Please add "PCD File No. COM-21-028"

Project Name:
**LEANN WILSON & ASSOCIATES
 NEW OFFICE BUILDING**
 SHEET NAME:
 SITE PLAN

Sheet No:
G-2

Site Plan_V1_Redlines.pdf Markup Summary

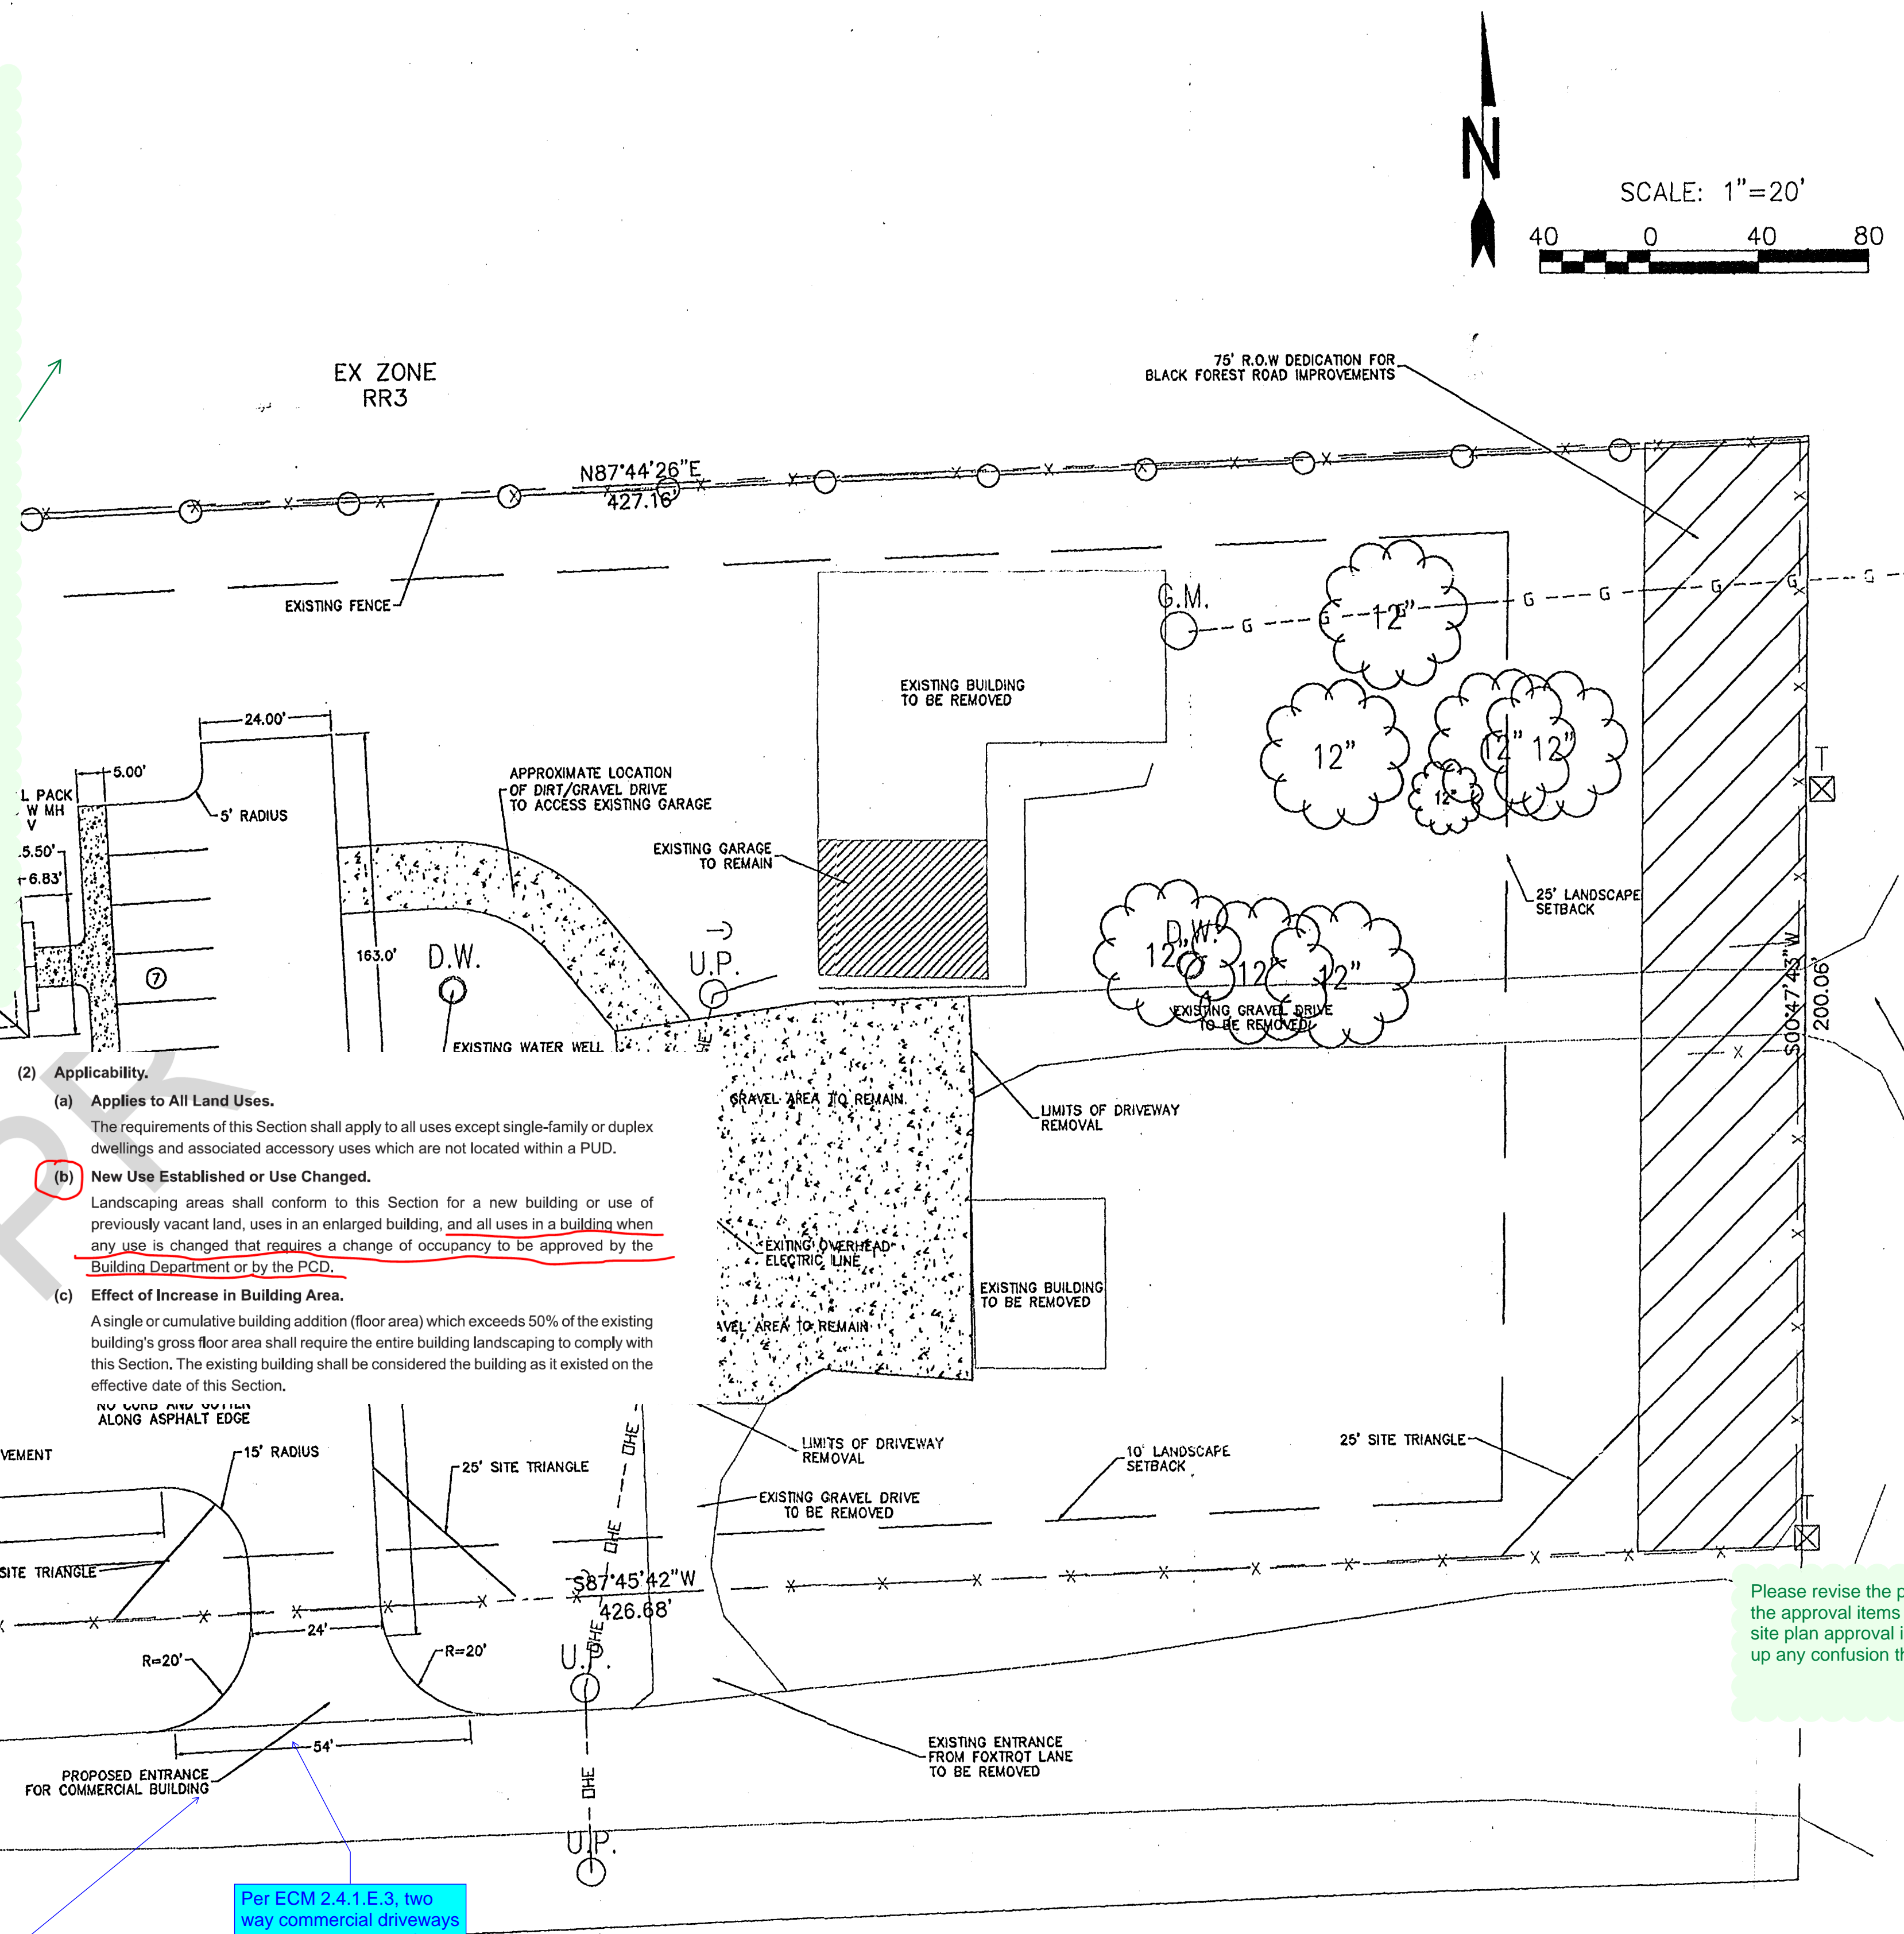
Landscape requirements for commercial uses per LDC CH. 6 apply, pursuant to the below applicability subsection:

Please note that landscaped areas (including no. of trees) within required landscape buffer areas, as well as parking areas, do not count toward internal landscaping requirement. Internal landscaping shall either be:

1. Adjacent to the building;
2. At all pedestrian entrances;
3. Within a plaza or courtyard;
4. In an area provided to separate building from parking lot; or
5. In an area provided to separate building from parking lot; or
5. In an area provided to separate building from parking lot; or

Please refer to all landscape standards within LDC Chapter 6 and revise site landscaping to comply. If landscaping requirements will not comply, then an alternative landscape plan may be proposed and justified according to the criteria outlined in the below snip from Ch. 6 of the LDC:

Some components of this plan are outdated, including the property's zoning designation, which is now CC. (Also, Max building height for the CC district is 40', not 30', etc.)

Also, the property size shows as 1.82 on the Assessor, not 1.96.

Please revise the plan accordingly throughout.

Please apply for a commercial driveway access permit. Contact Petra Rangel at petrarangel@elpasoco.com for assistance in obtaining one.

Per ECM 2.4.1.E.3, two way commercial driveways can be a maximum of 40 foot access width. Please revise to meet criteria.

This plan is outdated, so the parking requirements are now out of date and incorrect, too. The parking requirement is 1 space per 200 SF. The parking and maneuvering standards of LDC Ch. 6 do not apply/ are not triggered for this COM project per the applicability subsection within the parking standards, so the existing parking will not be required to meet current code standards. However, please revise the parking table here to be accurate with the current parking ratio in Ch. 6 parking standards.

Please revise the plan date and remove the approval items here from the previous site plan approval in 2005. This is to clear up any confusion that may arise.
